Enclosure 4

Edwin I. Hatch Nuclear Plant  
Response to Second RFAI  
Power Uprate Submittal

Page Change Instructions

Figure 3.4.1-1 (Page 1 of 1)  
Power-Flow Operating Map with One Reactor  
Coolant System Recirculation Loop in Operation

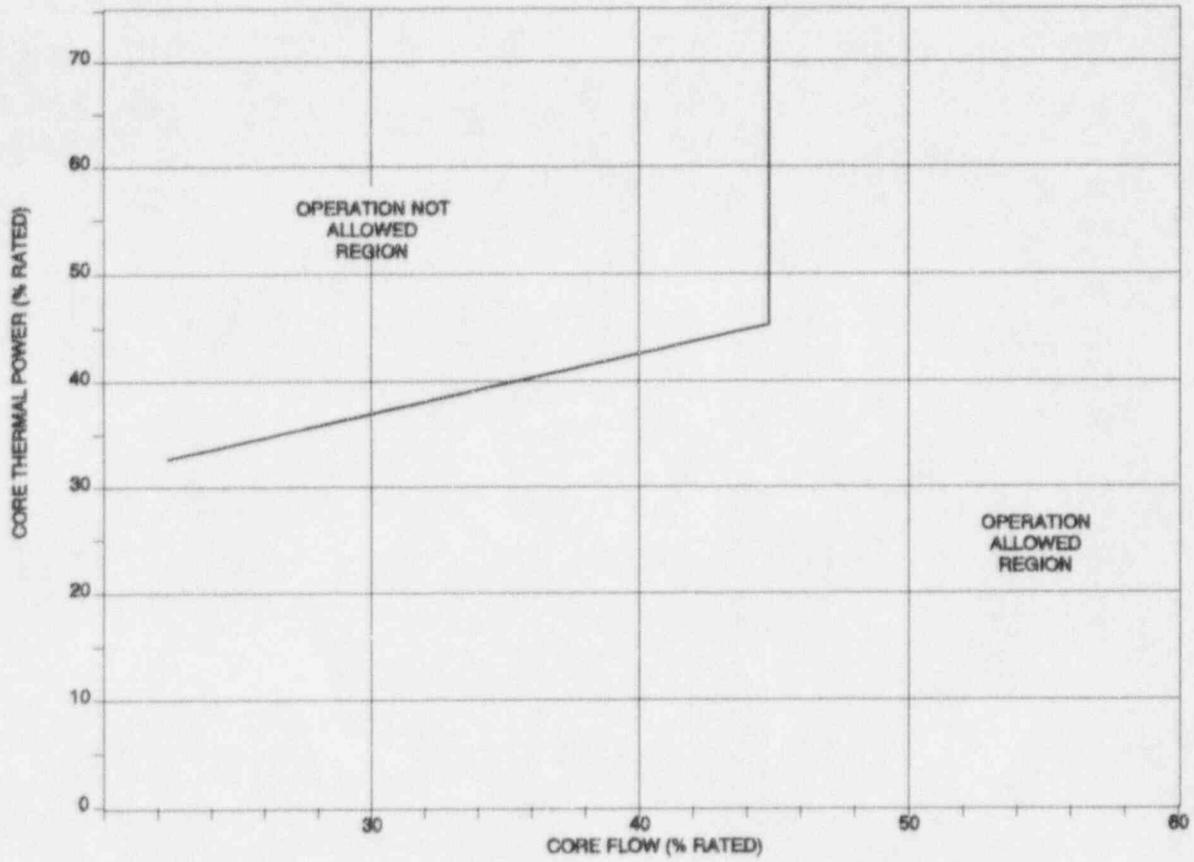
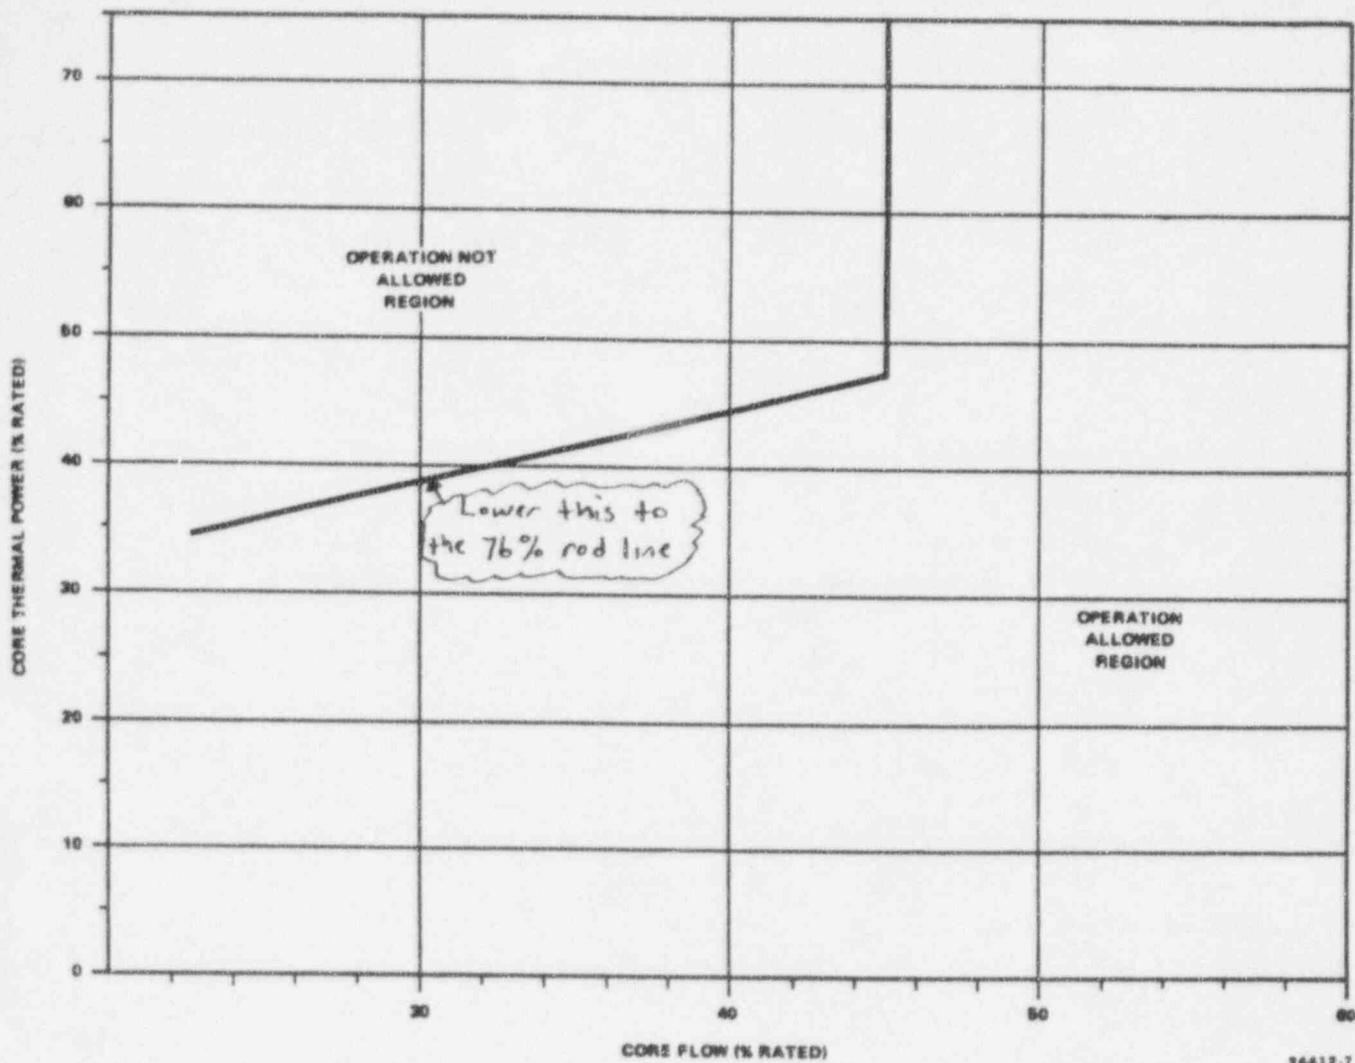
Figure 3.4.1-1 (Page 1 of 1)  
Power-Flow Operating Map with One Reactor  
Coolant System Recirculation Loop in Operation

Figure 3.4.1-1 (Page 1 of 1)  
Power-Flow Operating Map with One Reactor  
Coolant System Recirculation Loop in Operation

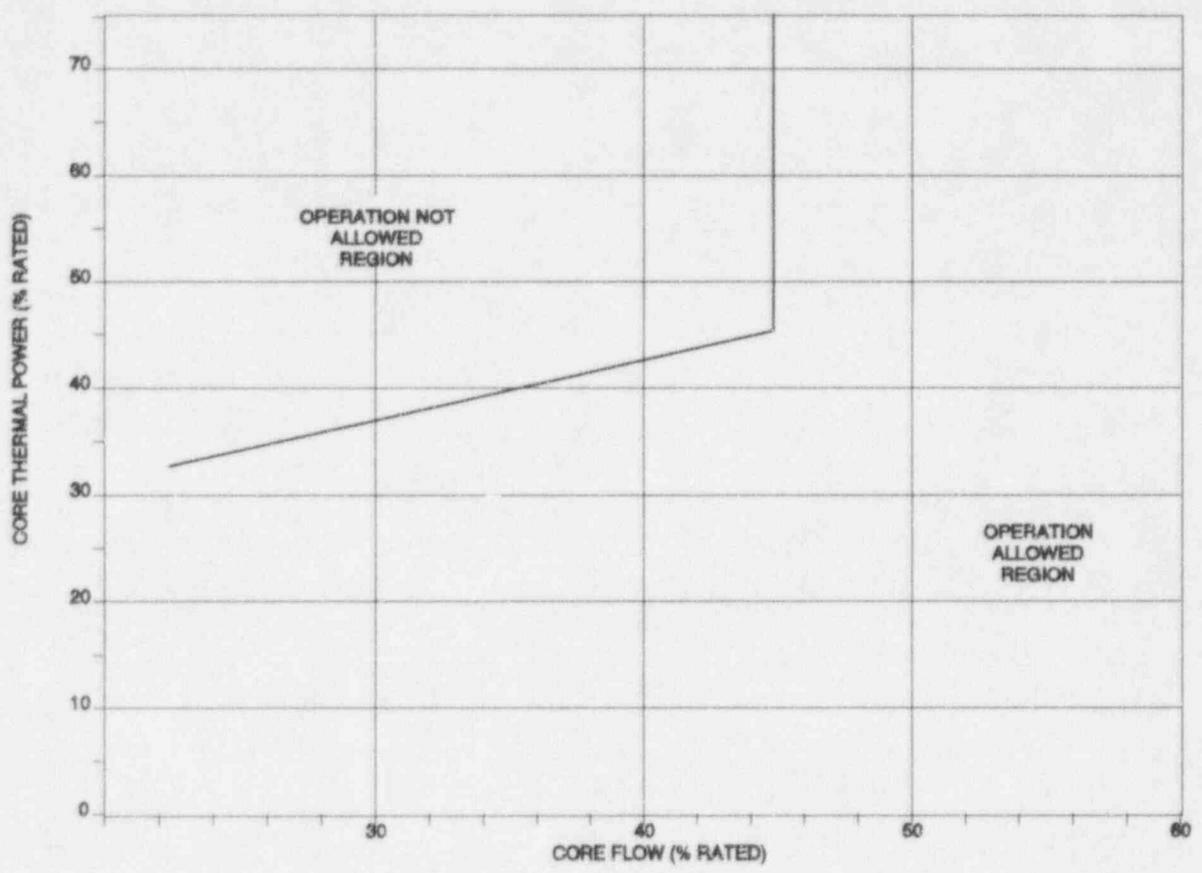
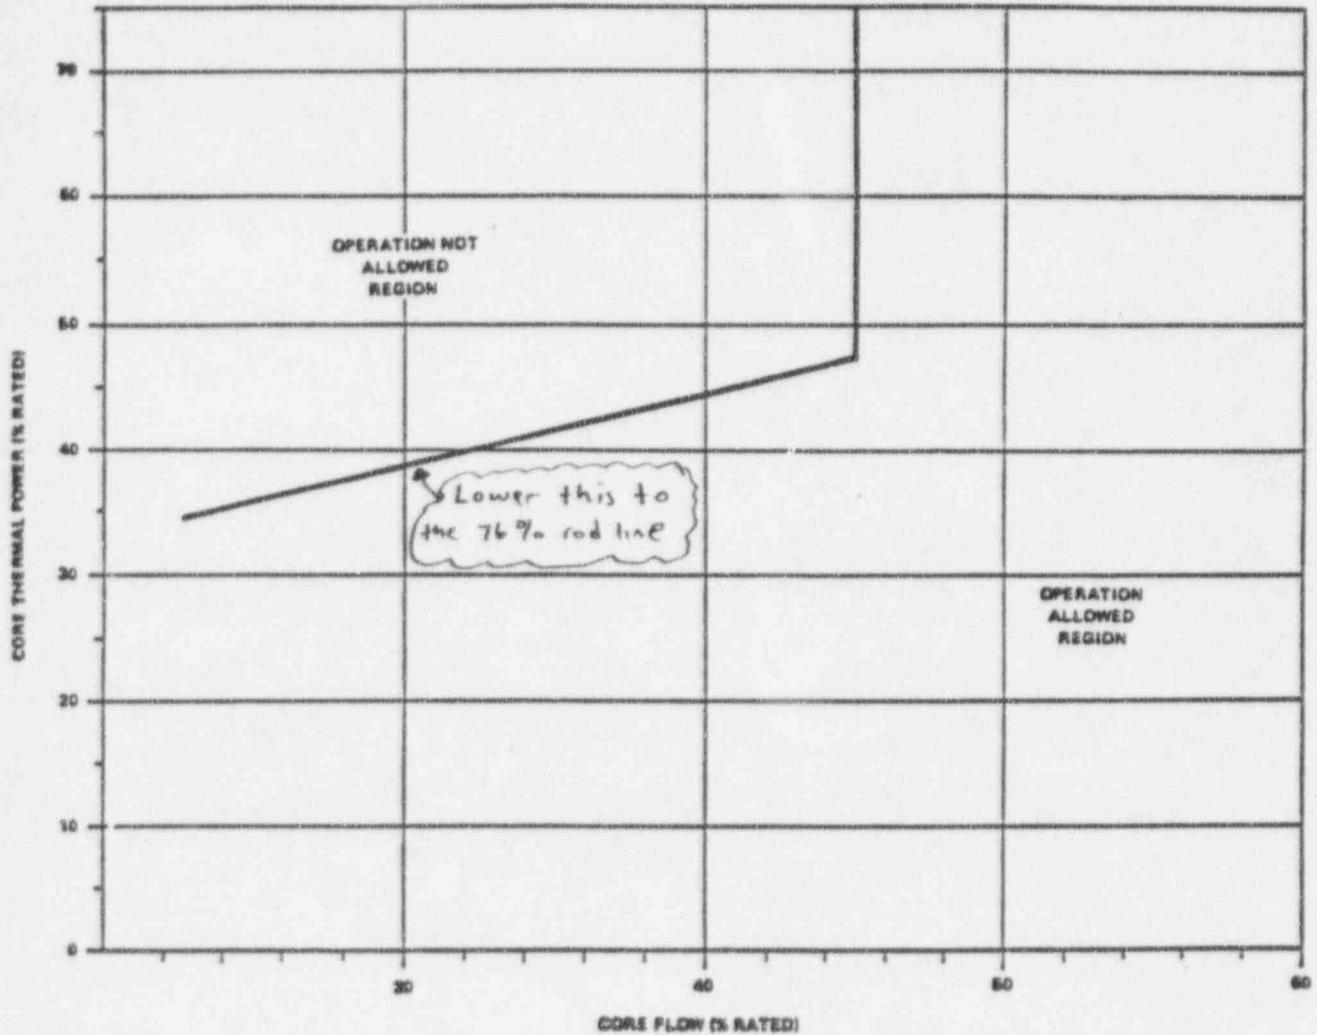
Figure 3.4.1-1 (Page 1 of 1)  
Power-Flow Operating Map with One Reactor  
Coolant System Recirculation Loop in Operation
